SURVEY REQUEST FORM

Topo and locations/elevations of pond at Village at
River bend

FELLER, FINCH & ASSOCIATES, INC.			
REVISION	DATE	DESIGN BY: CMG	
		DRAWN BY: RGS	
		DATE: 8-08-15	
		CHK'D BY: GNF	
		DRAWING NO: 07849SWP301A

WEIR DETAILS

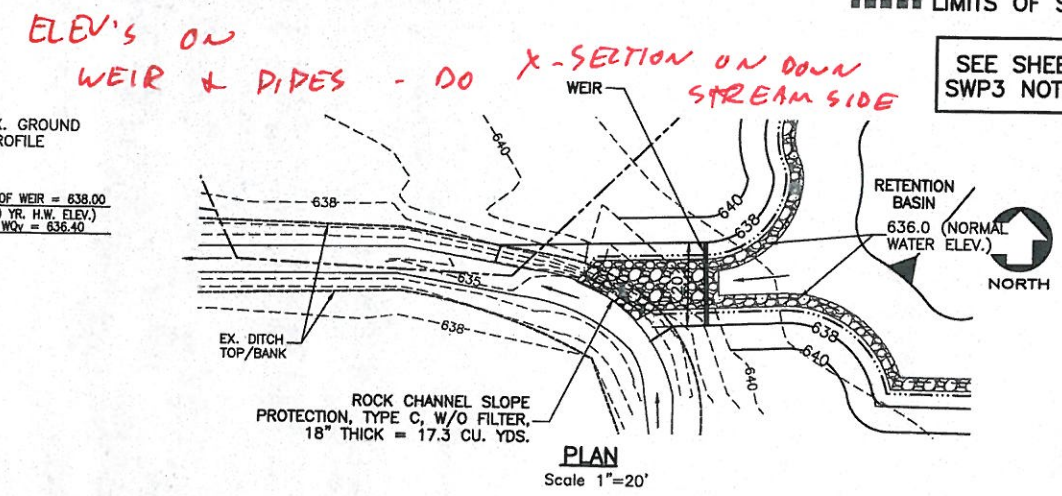
ELEV'S ON WEIR & PIPES - DO X-SECTION ON DOWN STREAM SIDE
